Timing Plate Flange Screw
D13
VAH, VHD, VN

FSB 215-003, Timing Plate Flange Screw

(May 2015)

W2005945

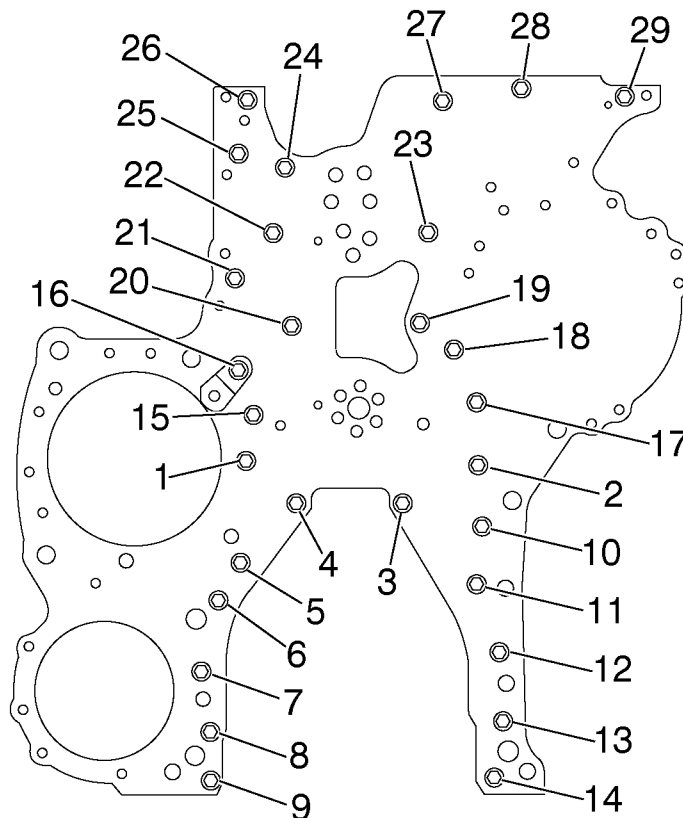
An improved flange screw with pre-applied locking compound (patch-lock) was introduced in production on April 27, 2015 for VOLVO D13 engines. In the event that the timing plate is removed, replace all 29 MP8*25 timing plate screws with screw part number 994447. Torque procedures remain the same as listed in specifications.
